LAWRENCE HISTORIC RESOURCES COMMISSION
AGENDA FOR **JANUARY 18, 2018**
CITY HALL, 6 E 6TH STREET
6:30 PM

ITEM NO. 5: DR-17-00344 700 New Hampshire Street; Demolition and New Construction; Certificate of Appropriateness and Downtown Design Guidelines Review. The property is located in the environs of the Octavius W. McAllaster Residence (724 Rhode Island Street) and the A. J. Griffin House (645 Connecticut Street), Lawrence Register of Historic Places. The property is also located in the Downtown Urban Conservation Overlay District. Submitted by TreanorHL on behalf of Treanor Investments, LLC property owners of record.

**LAWRENCE HISTORIC RESOURCES
ADMINISTRATIVE REVIEW
STAFF REPORT**

Historic Walls

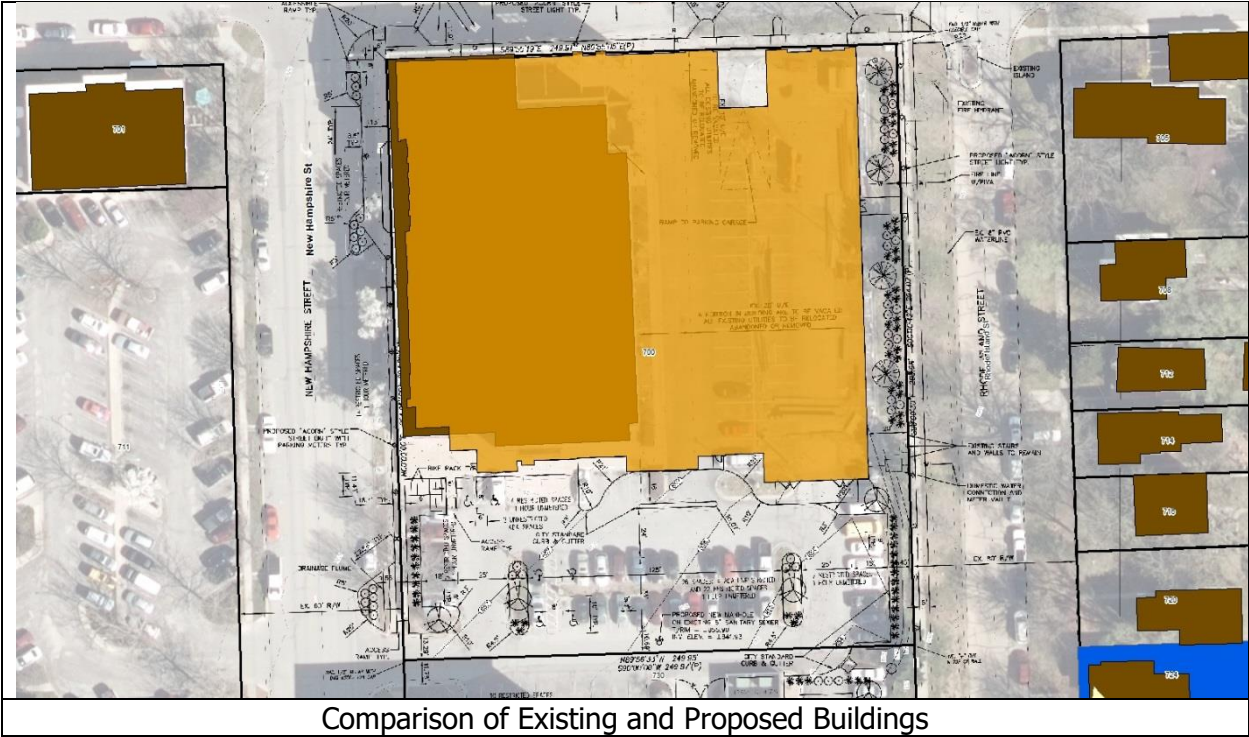
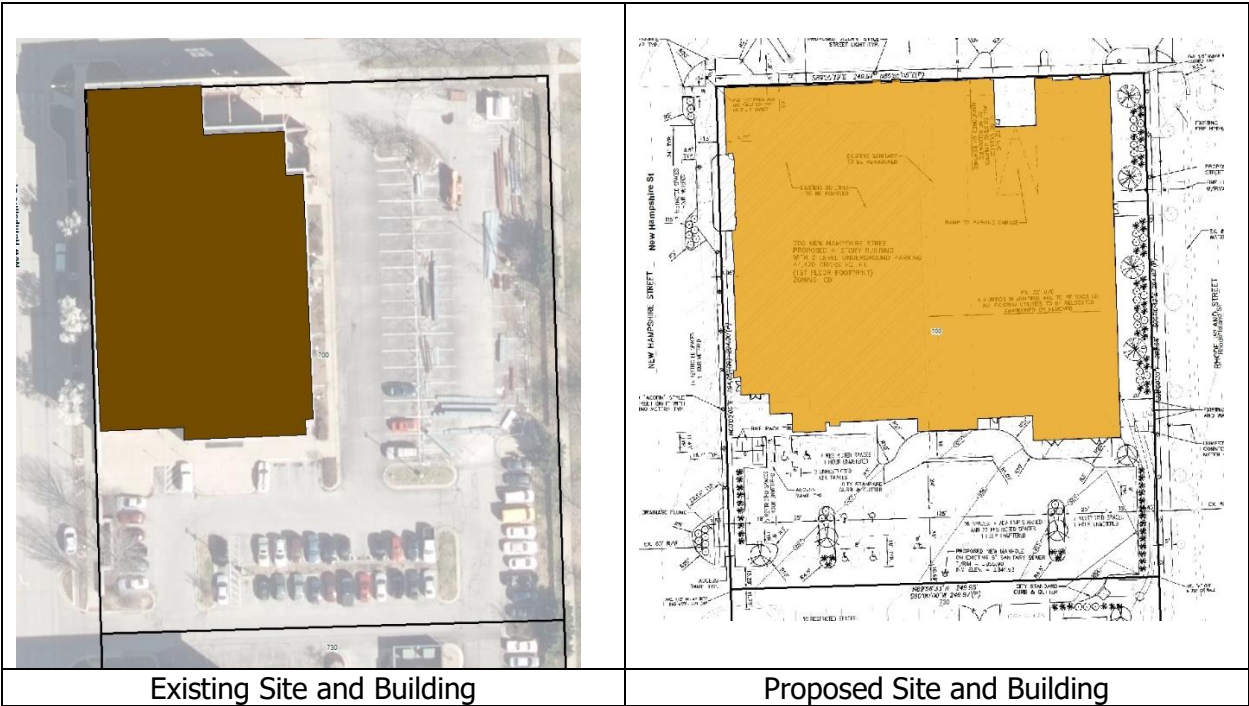
The first portion of the proposed project is the demolition of the existing structure located at 700 New Hampshire Street. This existing structure includes portions of two historic structures that were combined historically into one structure for one use. Maintained as part of the previous development project for the site, the oldest structure is one wall of a c. 1900 livery stable. This wall is likely the brick veneer of a building and withstood a 1912 fire and then an additional fire in 1916. The other historic structure is the adjacent two corner walls at the southeast corner of 7th Street and New Hampshire Street. This structure was built in 1916 after a fire in the livery stable building and was built as a garage. This structure is connected to the existing wall of the livery stable.

Demolition of historic structures is rarely positive for a historic area because it destroys the relationships between the structures, rhythms of the area, landscape features, and open space,

SITE PLAN

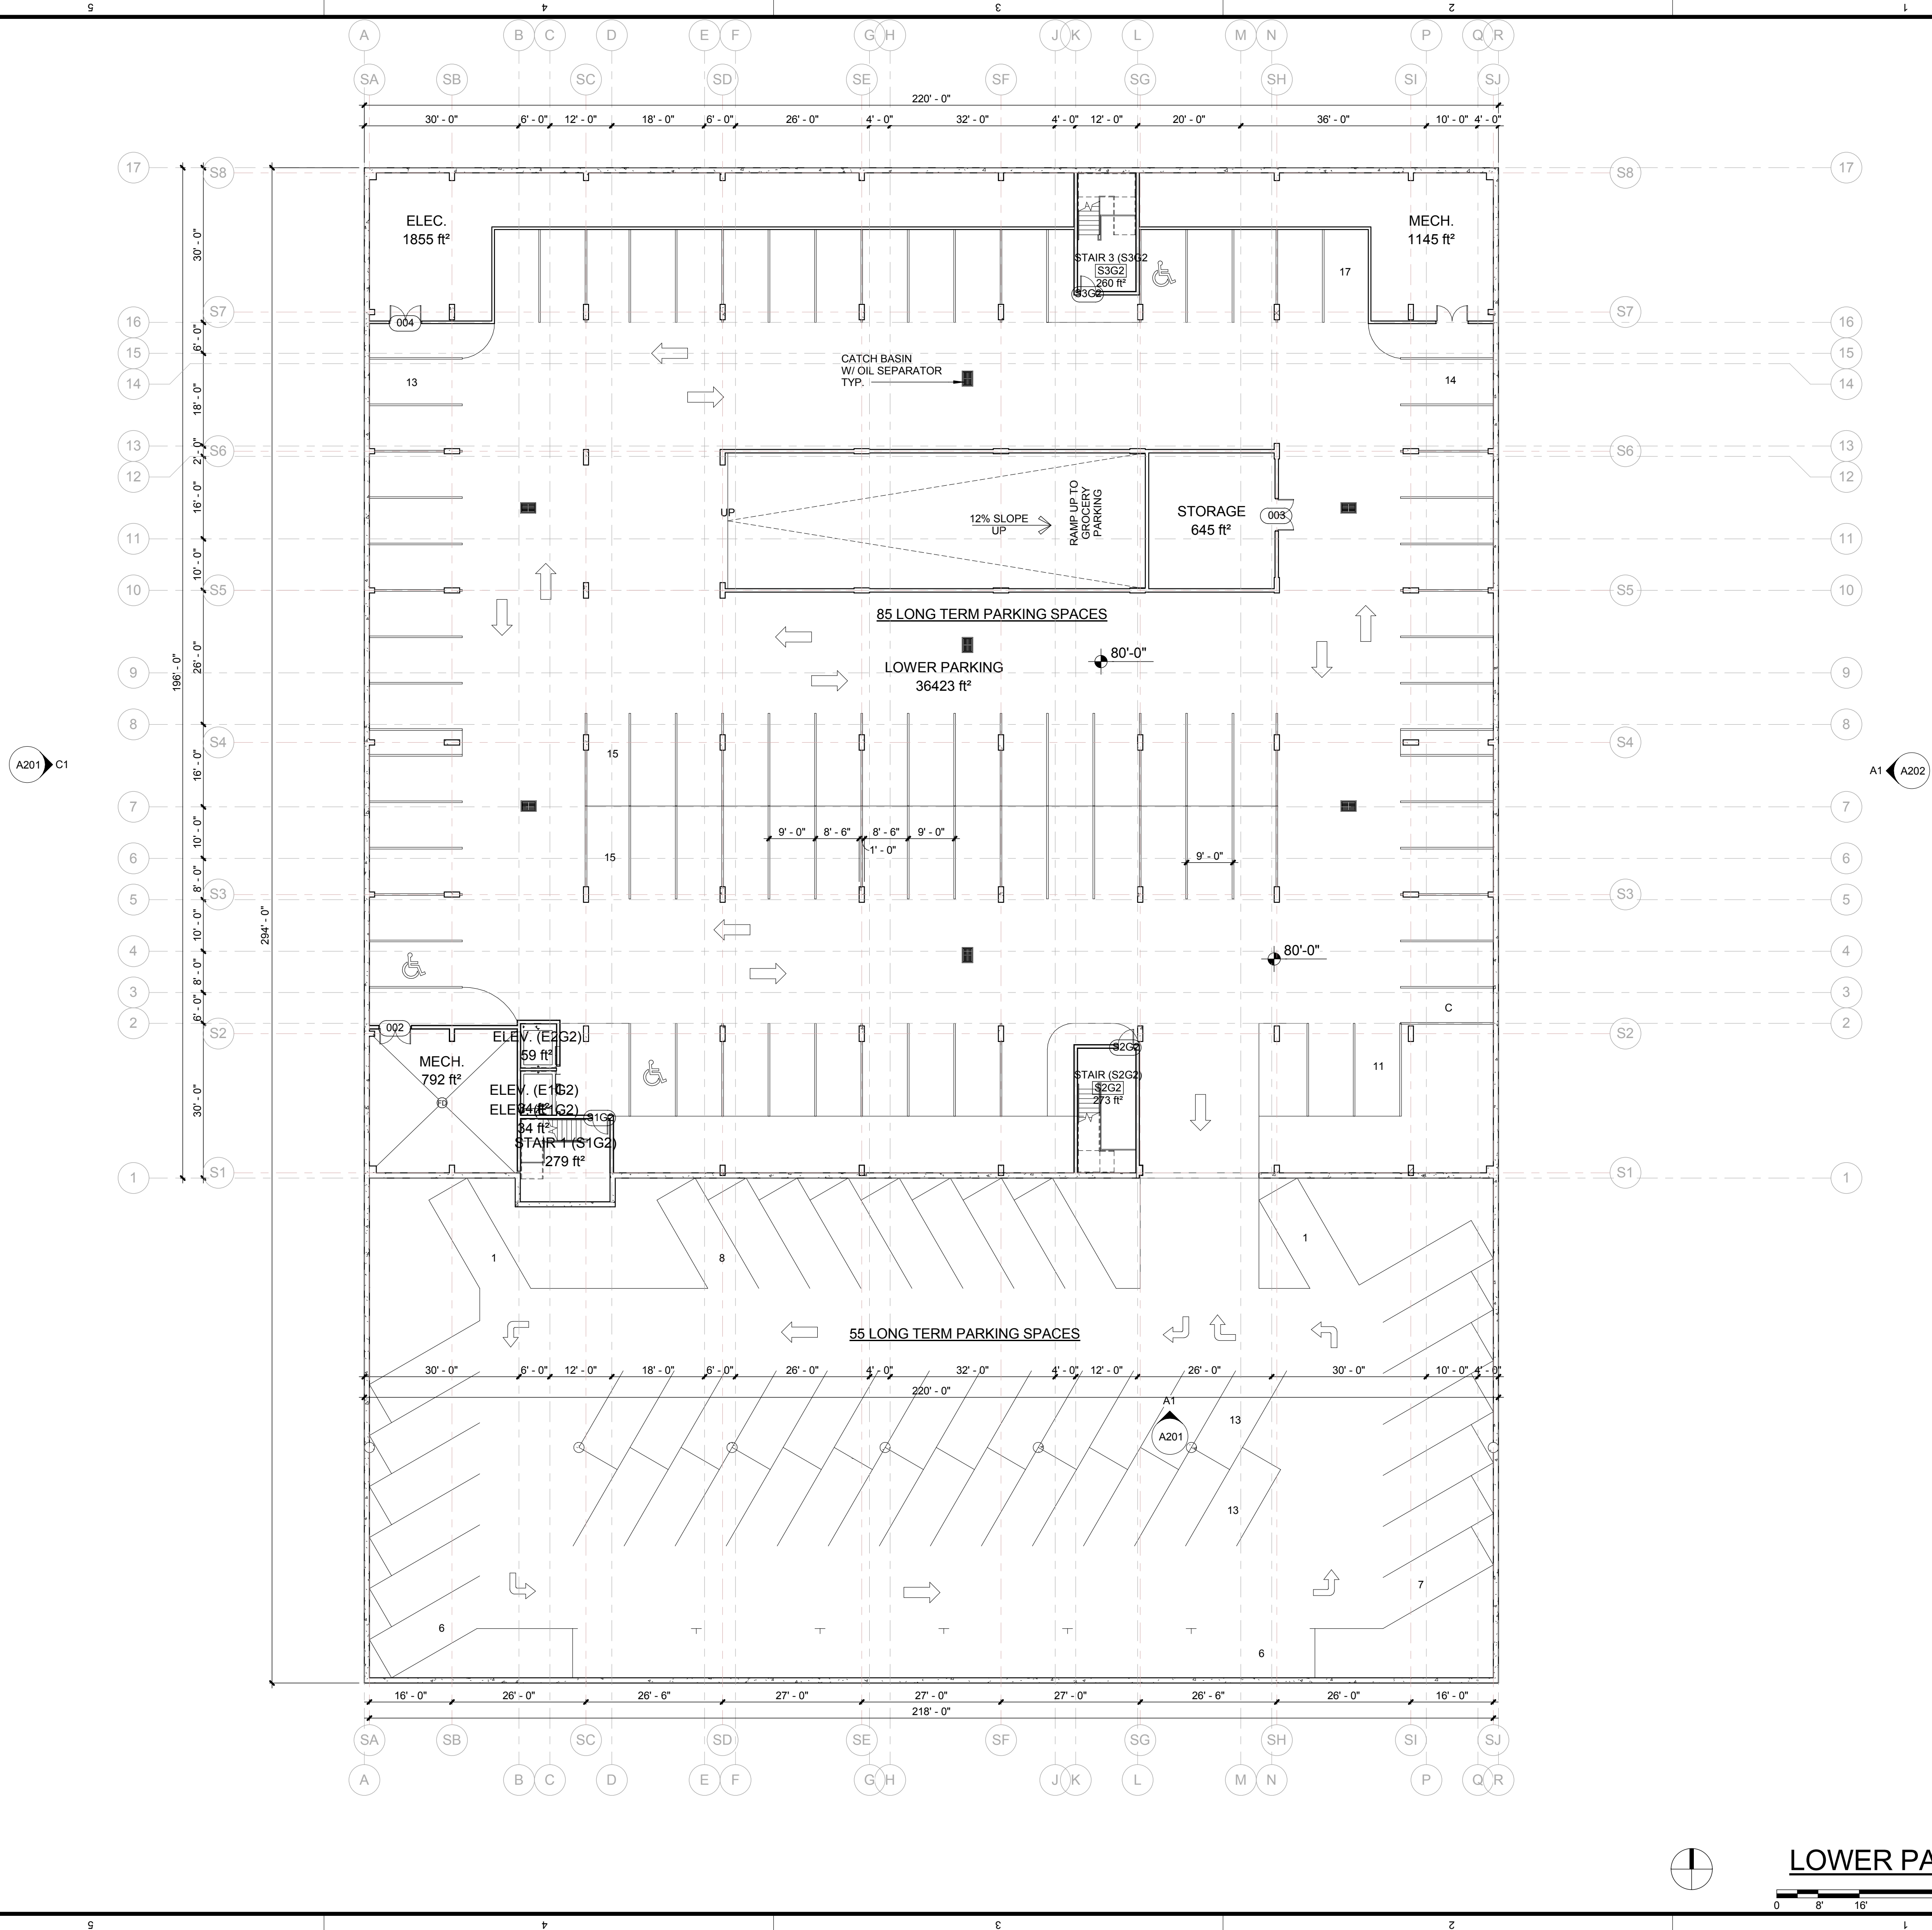
Although the alley has not been functional as an alley since the redevelopment of the site and parking lot area, the alley form exists and the alley continues to be used for vehicular movement for the parking lot with a slight shift to the east. The proposed project will totally remove this form and continued vehicular movement area.

A mid-block crossing should be added across New Hampshire Street.

This should be added to the plan.

EAST TO WEST BUILDING HEIGHT STUDY
NOT TO SCALE

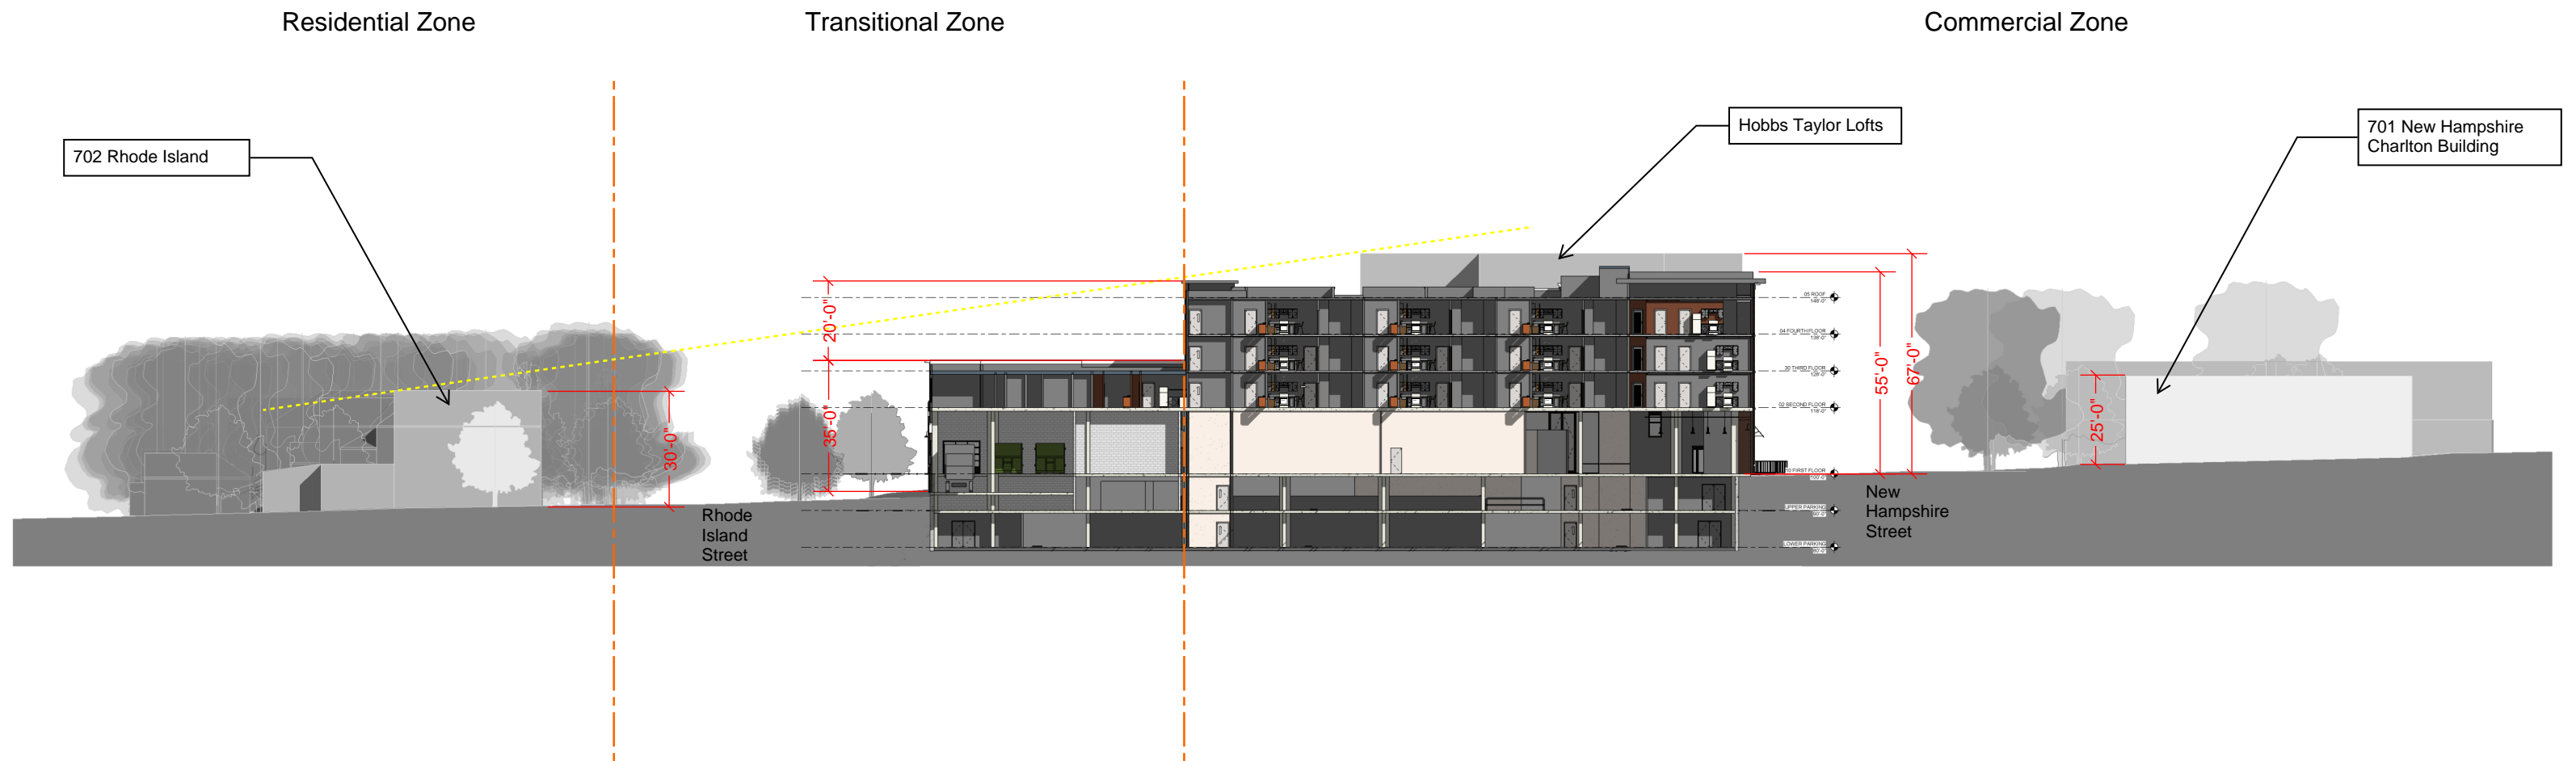
1. Change the rhythm of the New Hampshire Street division elements to reflect the significant character defining element of the 25' and 50' pattern ratios. This expression should be reflected appropriately with the associated upper stories. Recessed upper balcony areas should be removed.
2. The step down of the building to two stories to the east and the setback of the building from the east property line is an excellent transition to the residential neighborhood. Continue to achieve this transition to the residential neighborhood

14. Upper stories should have a development pattern that is a continuation of the street level façade.
15. Investigate opportunities to reduce the overall building height by the reduction in floor to ceiling heights.
